Sundry ID: 2684603

Type of Submission: Notice of Intent	Type of Action: Plug and Abandonment
Date Sundry Submitted: 07/28/2022	Time Sundry Submitted: 03:39
Date proposed operation will begin: 08/28/2022

Notice of Intent to PA
 Sundance 10 Federal 001
 30-015-28122
 OXY USA Inc.

**Permanent Abandonment of Federal Wells
Conditions of Approval (LPC Habitat)**

PROPOSED WELLBORE

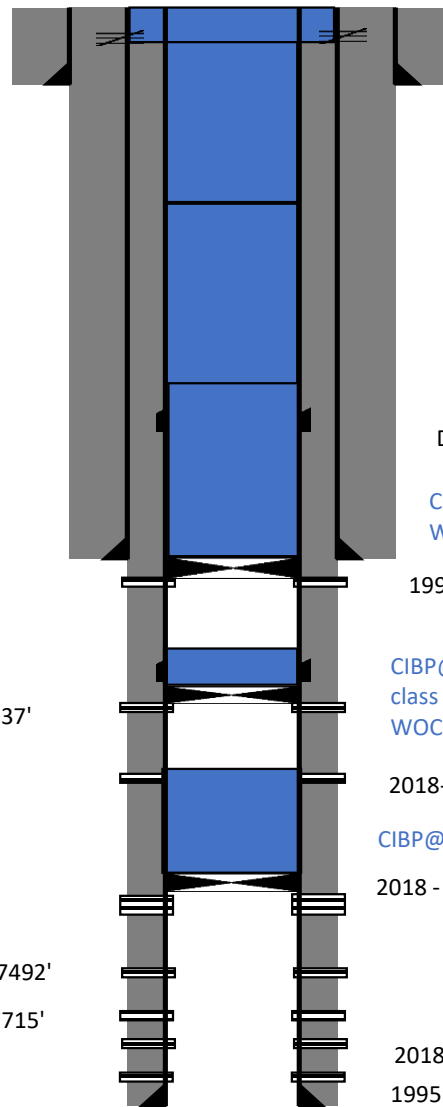
See COA for requirements.

Sundry ID		2684603				
Plug Type	Top	Bottom	Length	Tag	Sacks	Notes
Surface Plug	0.00	100.00	100.00	Tag/Verify	25.00	Perf and attempt squeeze at 100' to surface.
Shoe Plug	529.15	635.00	105.85	Tag/Verify		
Top of Salt @ 850	791.50	900.00	108.50	Tag/Verify	135.00	Spot from 1440' to 100'. WOC and Tag.
				If solid base no need to Tag (CIBP present and/or Mechanical Integrity Test), If Perf & Sqz then Tag, Leak Test all CIBP if no Open		
Fresh Water @ 868	809.32	918.00	108.68	Perforatio	145.00	Spot from 2874' to 1440'. WOC and Tag.
DV tool plug	2931.88	3062.00	130.12	Tag/Verify		
Base of Salt @ 4086	3995.14	4136.00	140.86	Tag/Verify		
Shoe Plug	4098.10	4240.00	141.90	Tag/Verify		
				If solid base no need to Tag (CIBP present and/or Mechanical Integrity Test), If Perf & Sqz then Tag, Leak Test all CIBP if no Open		
Delaware @ 4253	4160.47	4303.00	142.53	Perforatio

If solid base no need to Tag (CIBP present and/or Mechanical Integrity Test), If Perf & Sqz then Tag, Leak Test all CIBP if no Open Perforatio		
CIBP Plug	4275.00	4310.00	35.00		145.00	Set CIBP at 4310'. Spot from 4310' to 2874'. WOC and Tag. Leak test CIBP.
Perforations Plug (If No CIBP)	4292.14	4436.00	143.86	Tag/Verify		
DV tool plug	5880.10	6040.00	159.90	Tag/Verify		
				If solid base no need to Tag (CIBP present and/or Mechanical Integrity Test), If Perf & Sqz then Tag, Leak Test all CIBP if no Open Perforatio		
CIBP Plug	6305.00	6340.00	35.00		50.00	Set CIBP at 6340'. Spot from 6340' to 5880'. WOC and Tag.
Perforations Plug (If No CIBP)	6340.00	6587.00	247.00	Tag/Verify		
Brushy Canyon @ 6499	6384.01	6549.00	164.99	If solid		
Perforations Plug (If No CIBP)	6805.75	6975.00	169.25	Tag/Verify

If solid base no need to Tag (CIBP present and/or Mechanical Integrity Test), If Perf & Sqz then Tag, Leak Test all CIBP if no Open Perforatio		
CIBP Plug	7061.00	7096.00	35.00		30.00	Set CIBP at 7096'. Spot from 7096' to 6805'. WOC and Tag.
Perforations Plug (If No CIBP)	7096.00	7312.00	216.00	Tag/Verify		
Perforations Plug (If No CIBP)	7367.08	7542.00	174.92	Tag/Verify		
Perforations Plug (If No CIBP)	7587.85	7765.00	177.15	Tag/Verify		
Perforations Plug (If No CIBP)	7802.68	7982.00	179.32	Tag/Verify		
Perforations Plug (If No CIBP)	8017.51	8199.00	181.49	Tag/Verify		
				If solid base no need to Tag (CIBP present and/or Mechanical Integrity Test), If Perf & Sqz then Tag, Leak Test all CIBP if no Open Perforatio		
Bonesprings @ 8208	8075.92	8258.00	182.08			
Shoe Plug	8211.55	8395.00	183.45	Tag/Verify	35.00	Tag casing shoe at 8345' and spot cement from 8345' to 8075' to isolate the Brushy Canyon and the Bone Springs Formation. WOC and Tag.
